Approved Development Agreement Site Plan

Lynnett Road
2 0 2 1 . 0 3 . 3 0

Lynnett Road

Option 1

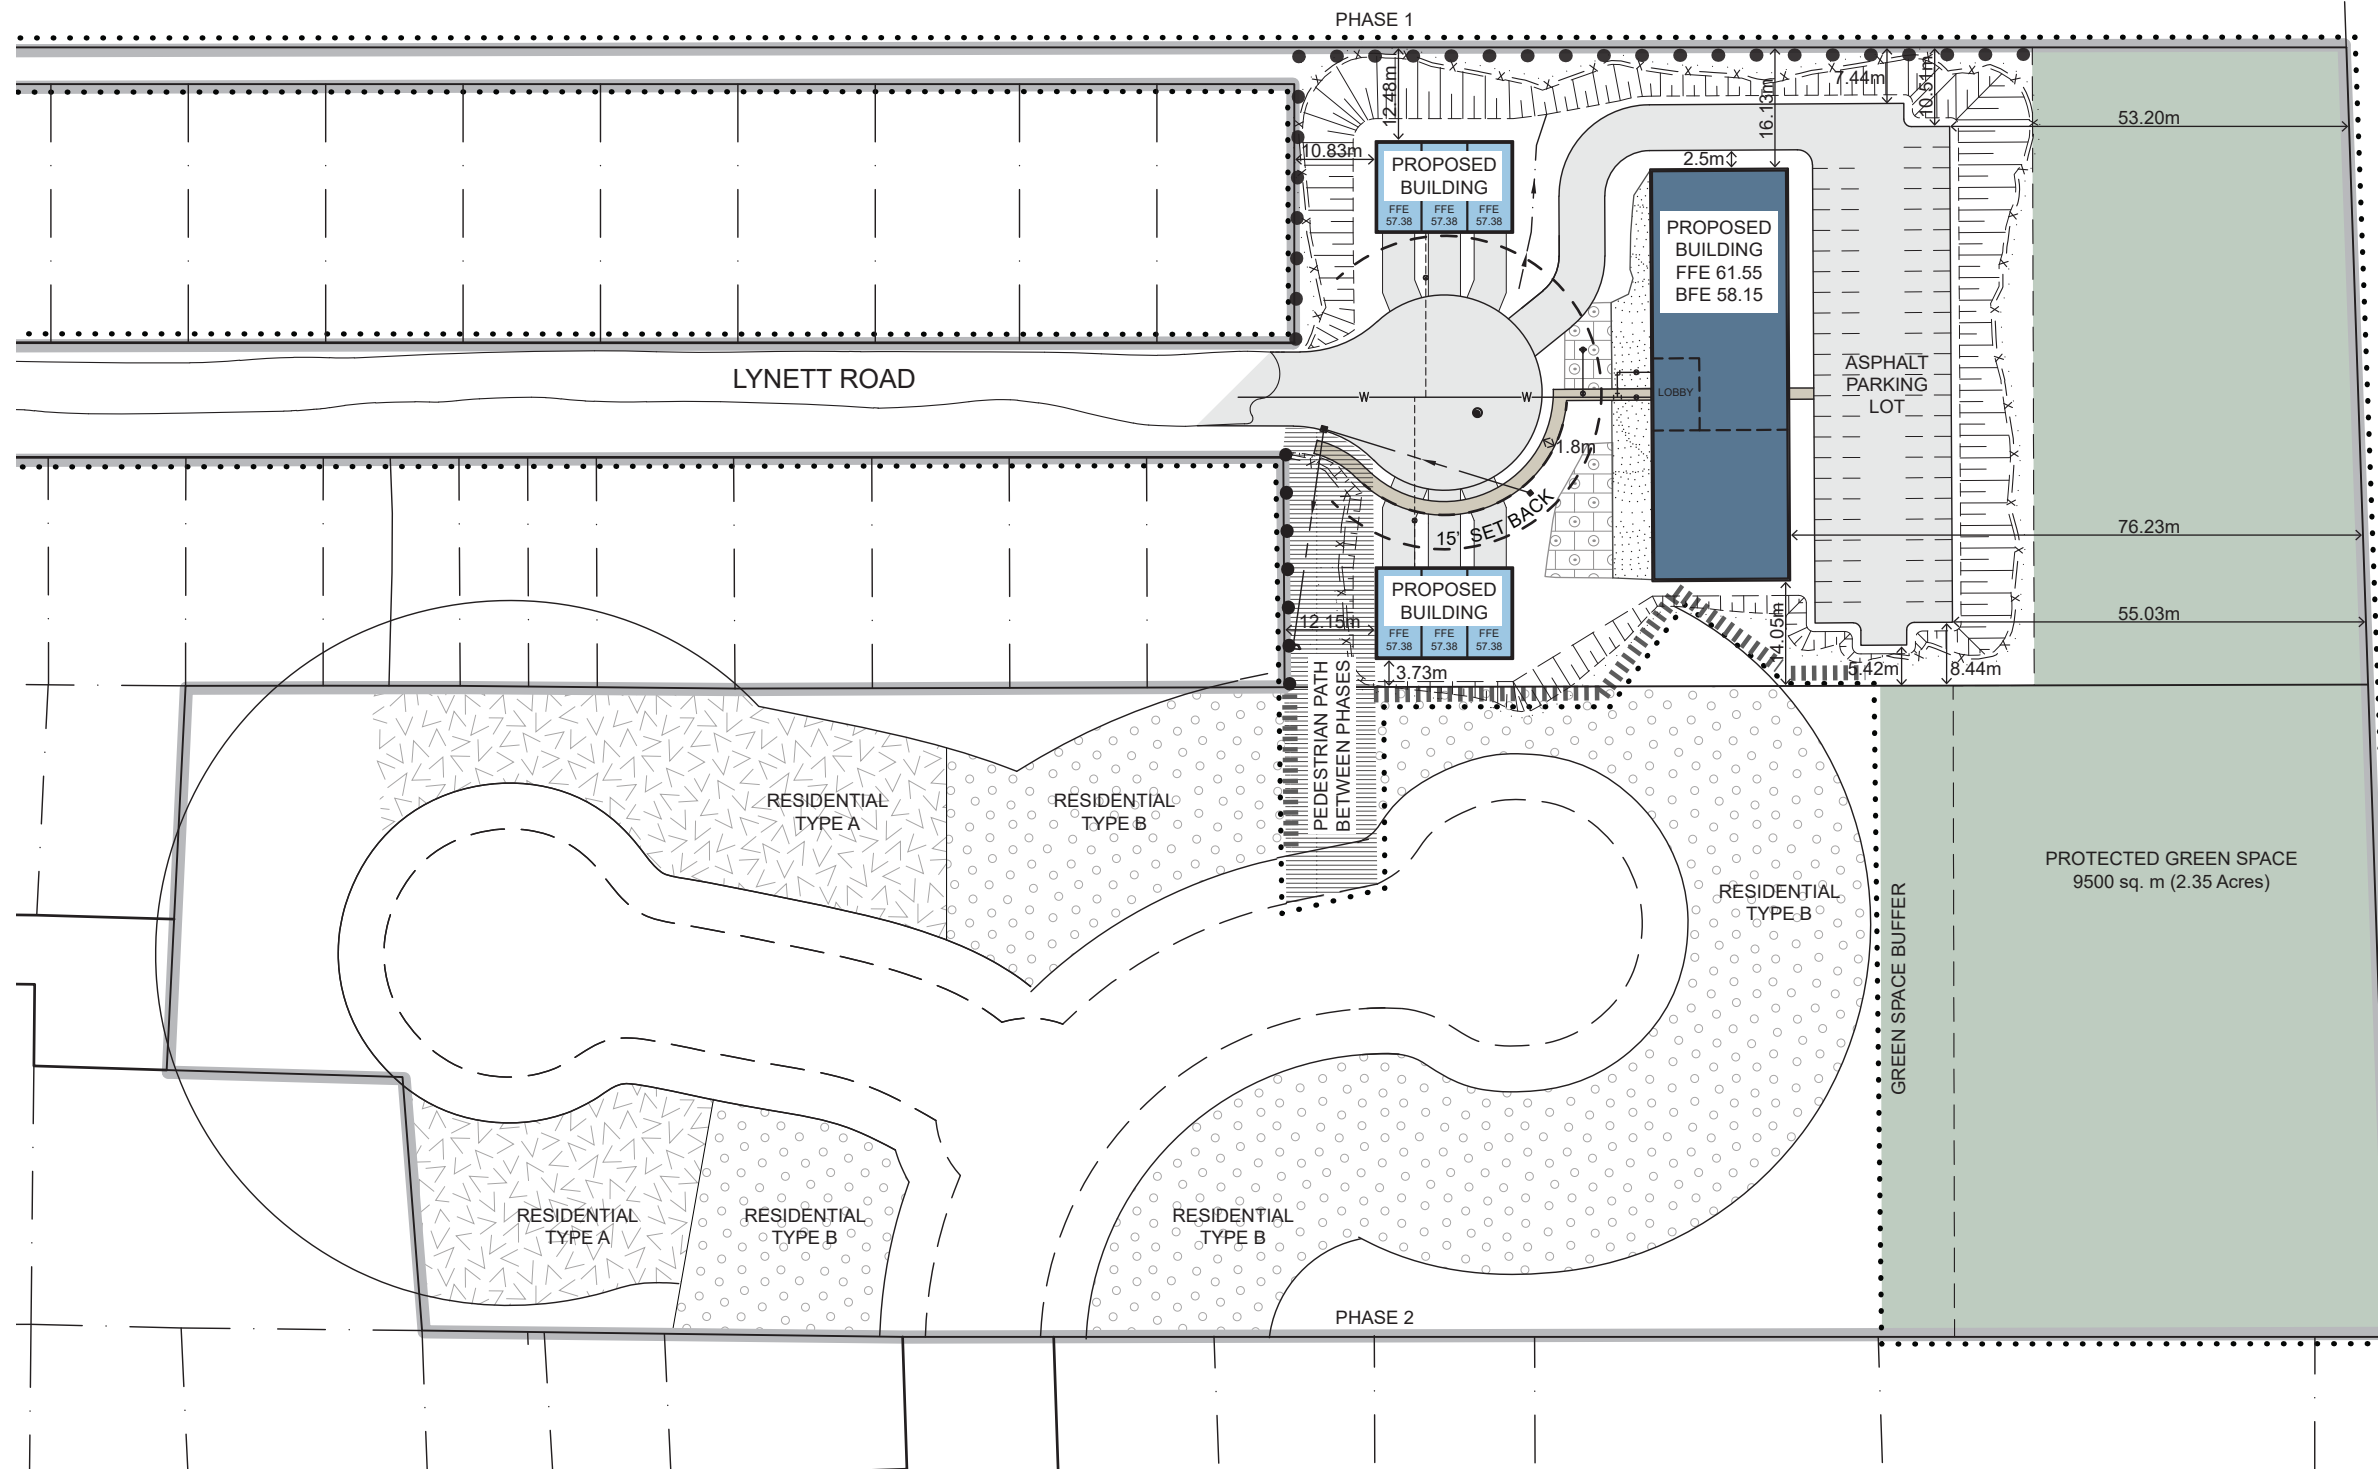
- numbers of dwellings amenity areas and parking spaces exactly the same as the approved DA
- all parking on grade
- increase protected greenspace 150sq.m compared with previous DA

Option 2

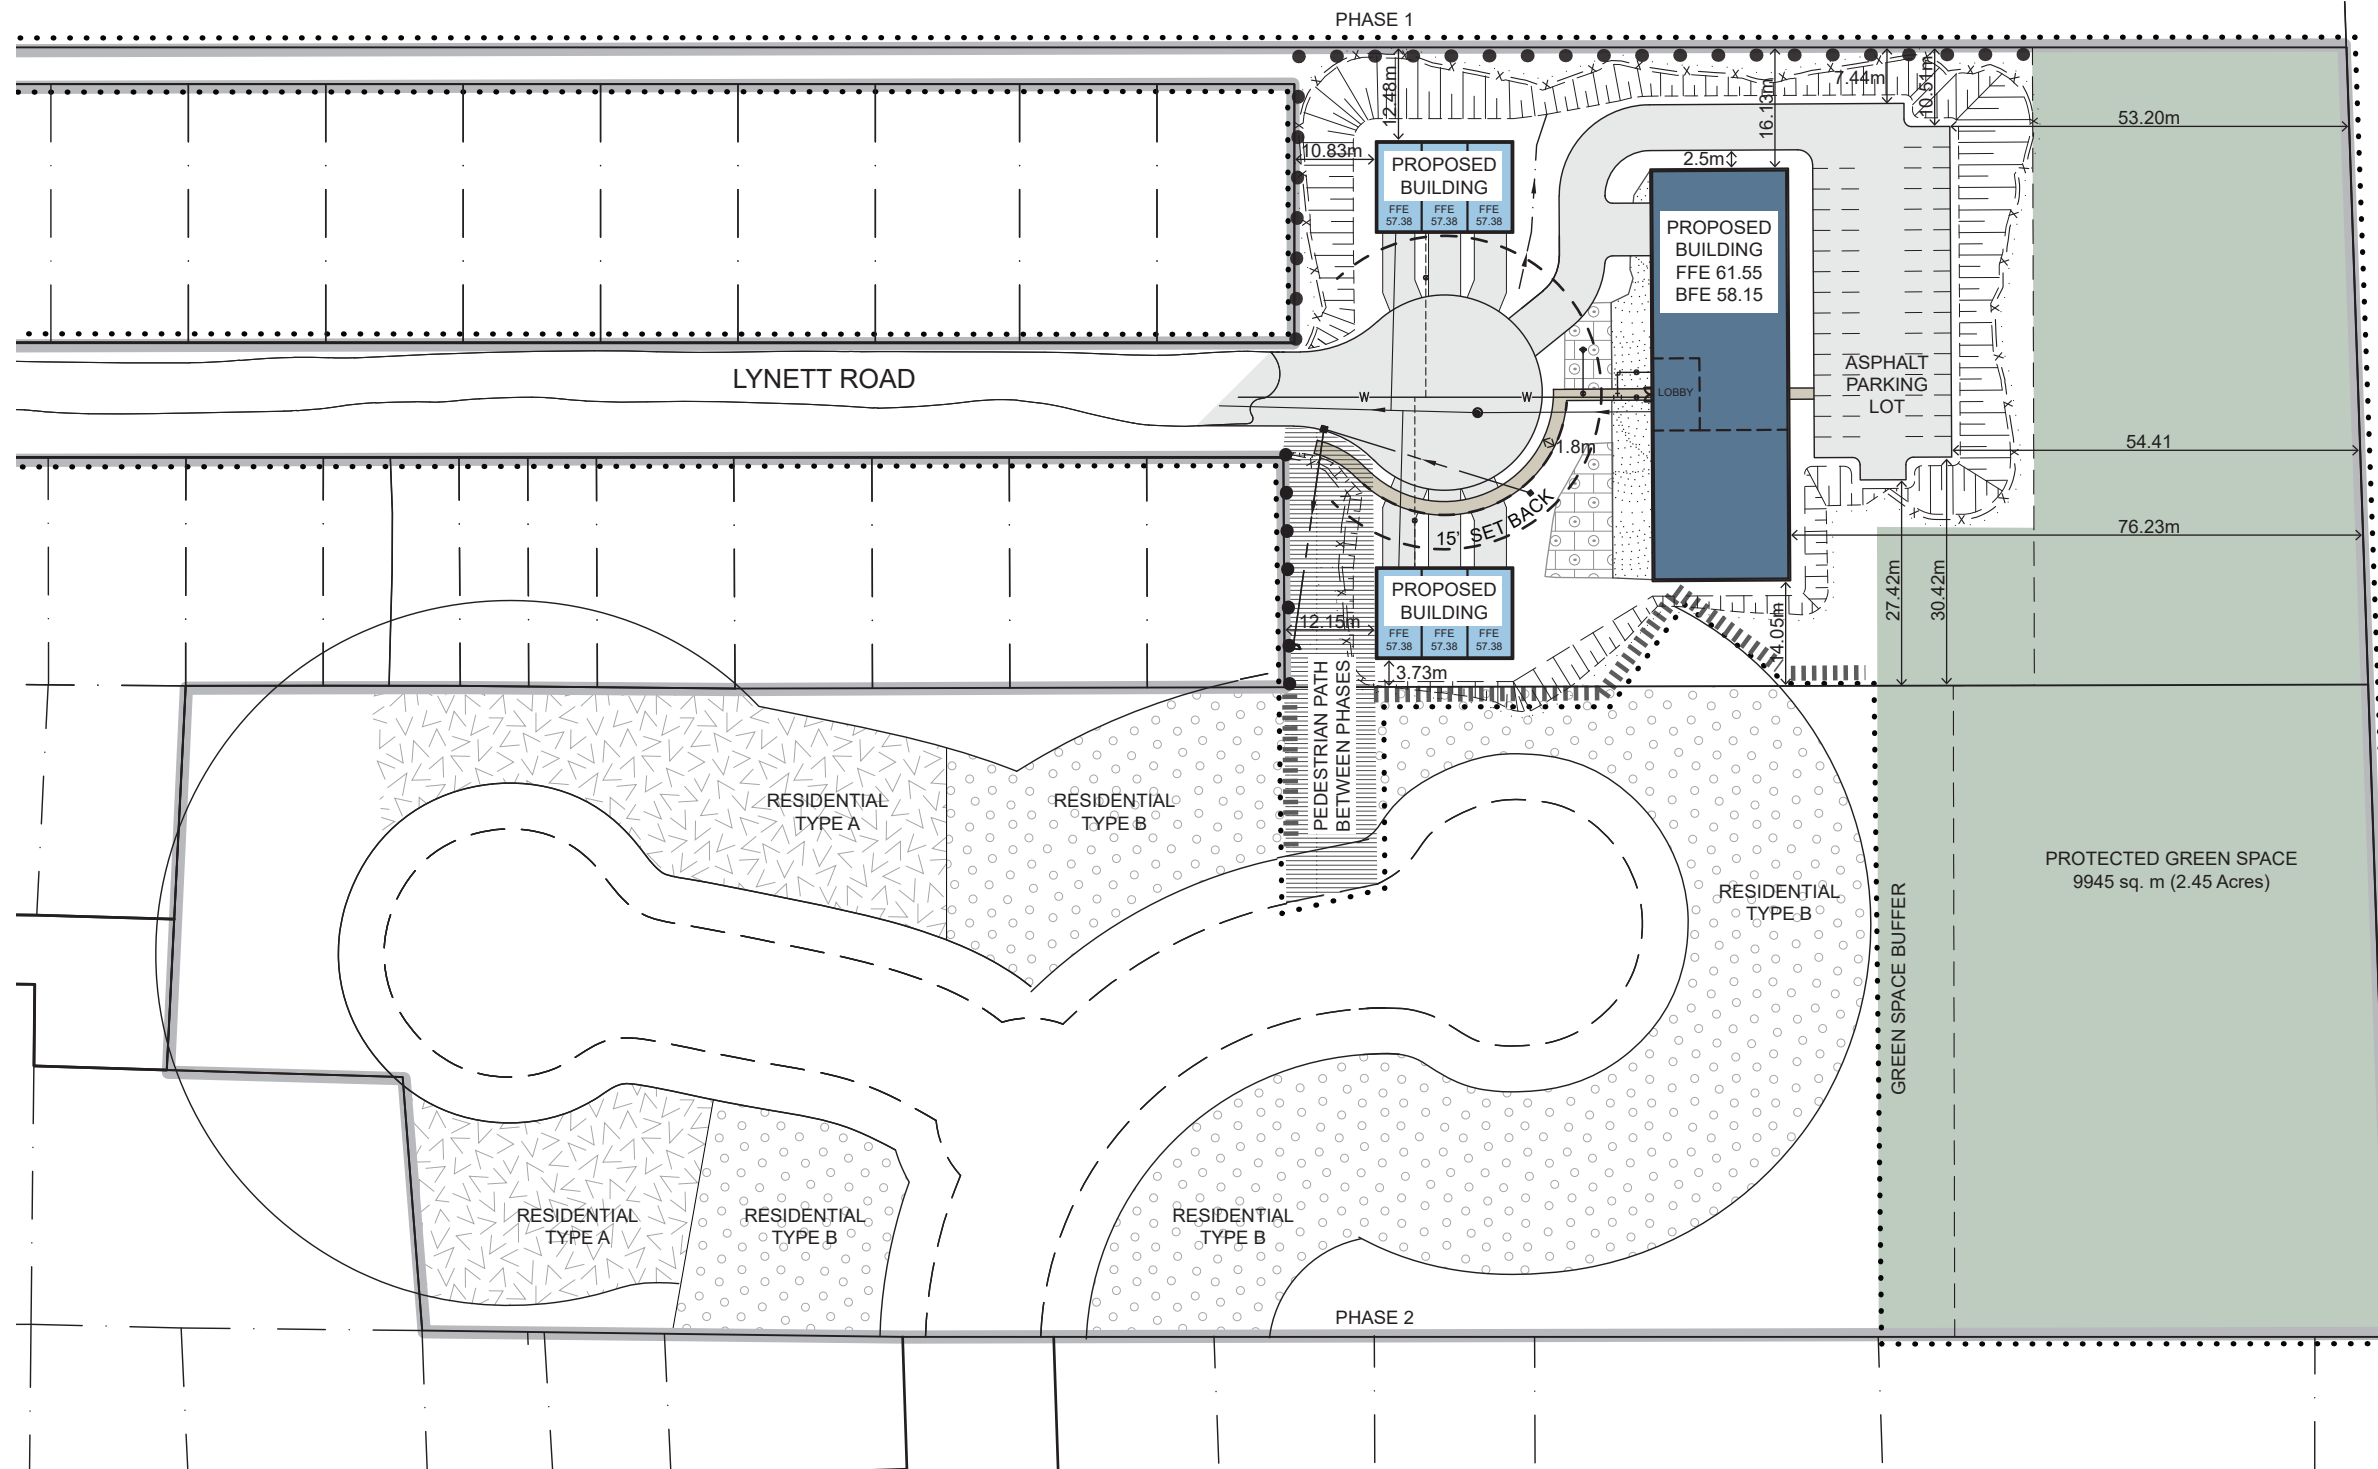
- numbers of dwellings amenity areas and parking spaces exactly the same as the approved DA
- up to 30% parking under building
- increase protected greenspace 595sq.m compared with previous DA

Proposed Pedestrian Pathway

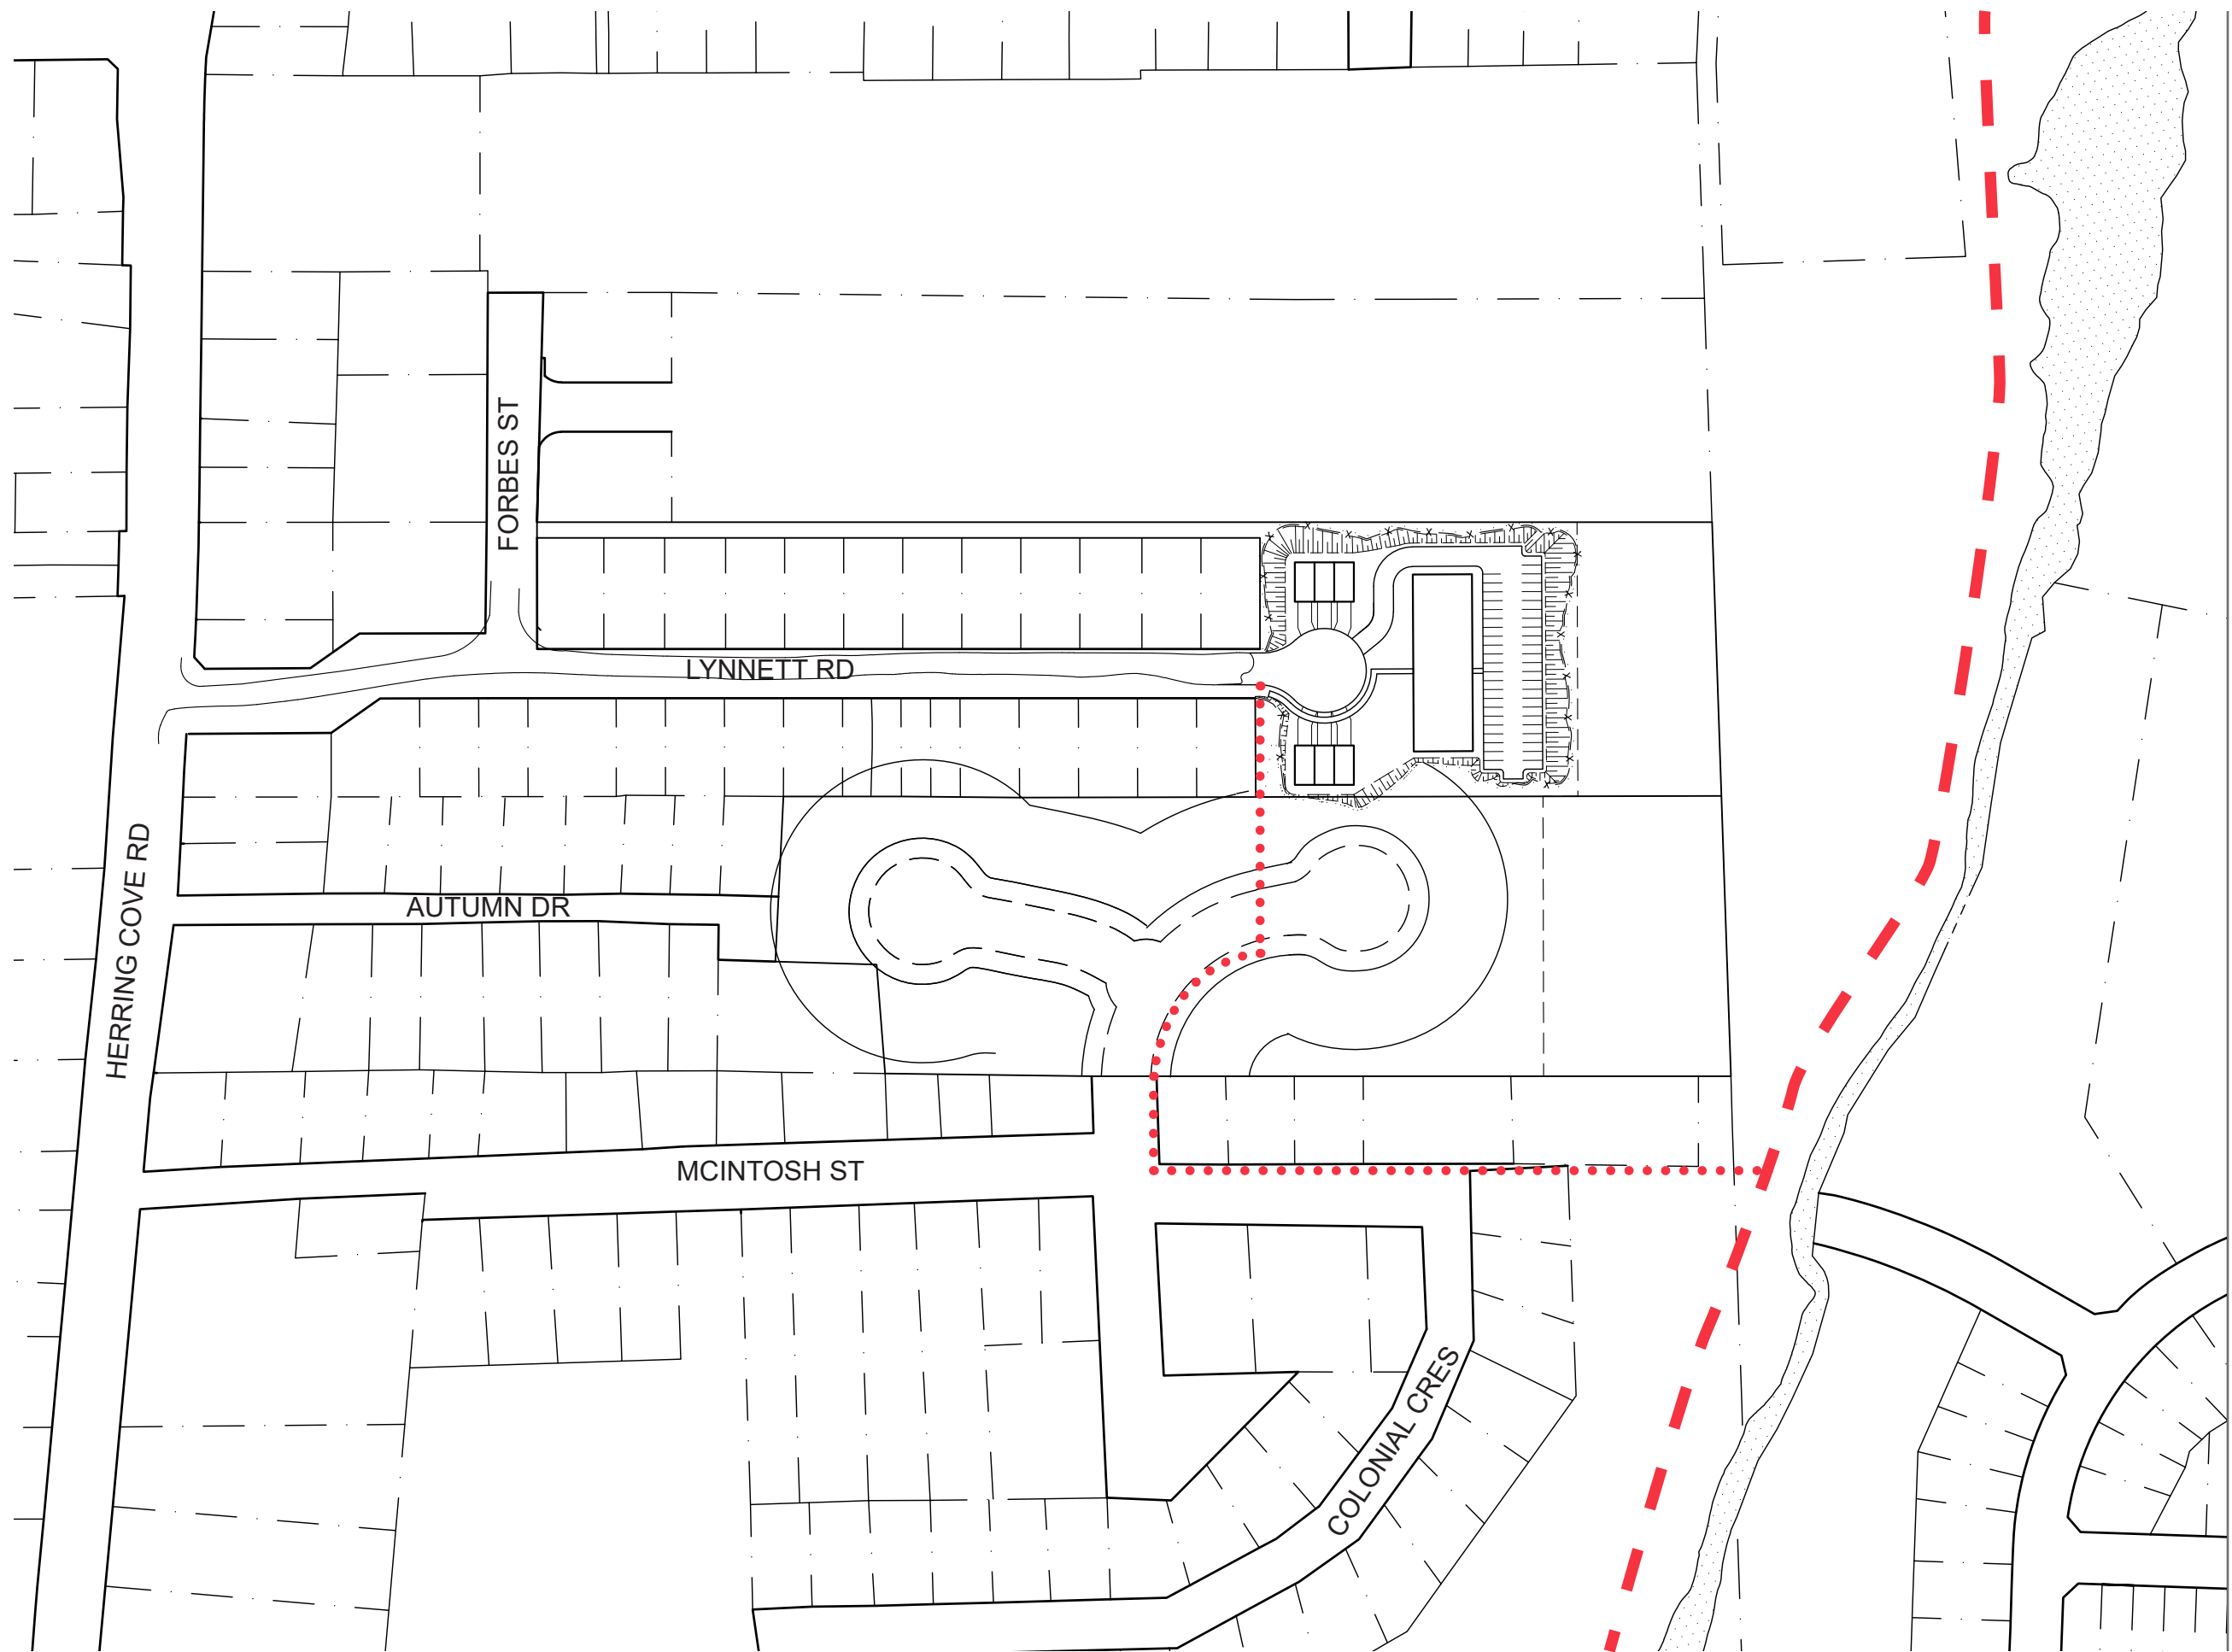
- increase access to pedestrian pathways
-  Existing Pedestrian Trail
-  Proposed Connection to Existing Pedestrian Trail
